## Würth Elektronik eiSos GmbH & Co. KG EMC & Inductive Solutions

Product / Process Change Notification (PCN)		
<ul><li>✓ Major change</li><li>☐ Minor change</li></ul>		
PCN#:	PCN_IndLHMI_20200124	Change Category:
Affected Series:	WE-LHMI-4012; 74437321xxx, S12100016, S12100017, S13100073	<ul><li>☐ Equipment / Location</li><li>☐ General Data</li><li>☐ Material</li><li>☐ Presses</li></ul>
PCN Date:	October 24, 2019	<ul><li>□ Process</li><li>⊠ Product Design</li></ul>
Effective Date:	January 24, 2020	<ul><li>☐ Shipping / Packaging</li><li>☐ Supplier</li><li>☐ Software</li></ul>
Contact:	Product Management	Data Sheet Change:
Phone:	+49 (0) 7942 - 945 5001	⊠ Yes □ No
Fax:	+49 (0) 7942 - 945 5179	Attachment:
E-Mail:	pcn.eisos@we-online.com	□ Yes ⊠ No
DESCRIPTION AND PURPOSE OF CHANGE:		
Due to an improvement of the production capability, Würth Elektronik will change the design on the bottom of the parts.		
All products with date code 2019-12-20 or later, will be affected by this change.

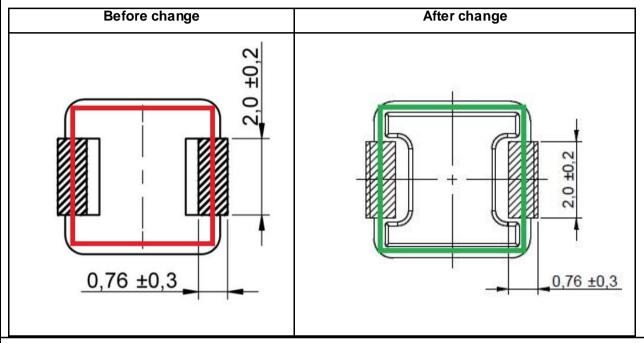
The previous shape of the indentation around the pins will be changed from square to round edges to increase the efficiency of the production process.
